REMARKS

Summary of Office Action

Summary of Amendments

FIG. 1

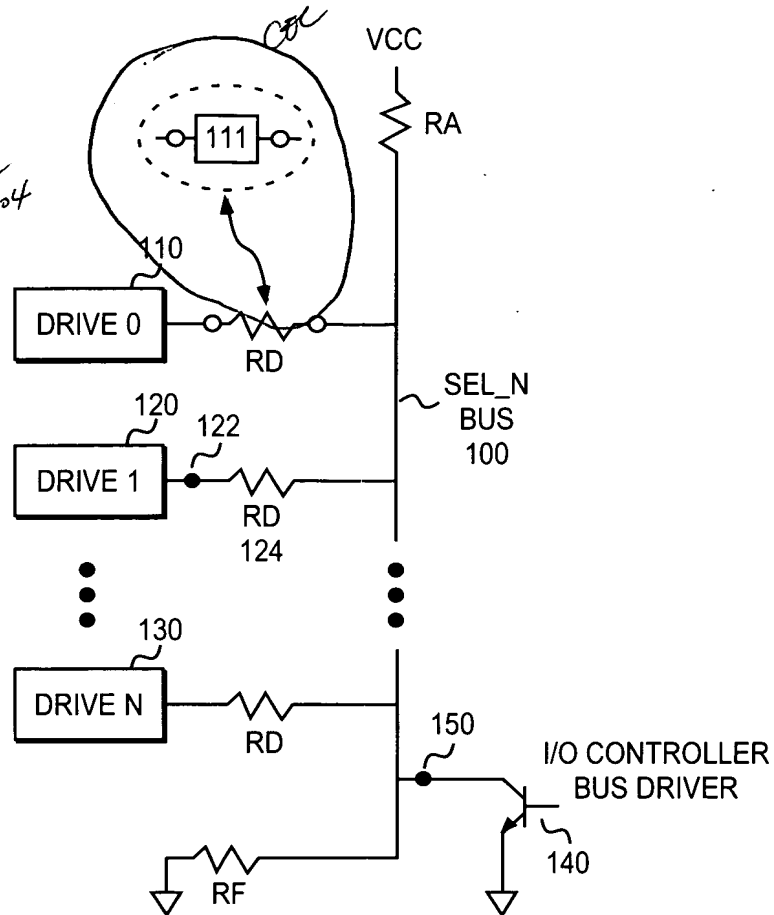
The drawings were also objected to because “they fail to show the isolation circuitry comprising active components as described in the specification”.

Figure 1 has been amended to include a reference to an active component 111. The specification has been amended at page 6 to include a reference to the character reference number 111.

Accompanying this Amendment is a replacement sheet for Figures 1-2 of the drawings. Figure 1 has been amended to illustrate an isolation circuitry comprising an active component 111. The specification has been amended at page 6 to include a reference to the character reference number 111.

FIG. 2

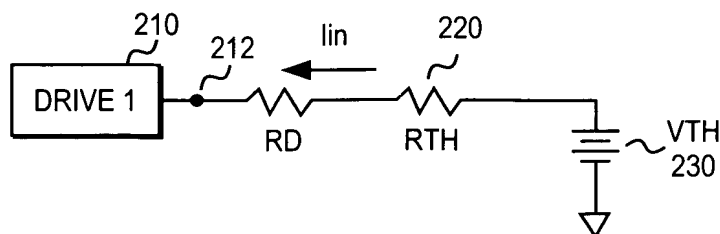
The drawings were objected to because the reference characters 220 and 230 of Figure 2 were not used in the specification (12/17/2003 Office Action, p. 2). As indicated above, the specification has been amended to refer to reference characters 220 and 230.

The specification was amended at page 6, Tables 1 and 2 to correct clerical errors. The specification was amended at page 7 to include reference characters illustrated in Figure 2. The specification was amended at page 10 to correct references to reference characters of Figure 5.
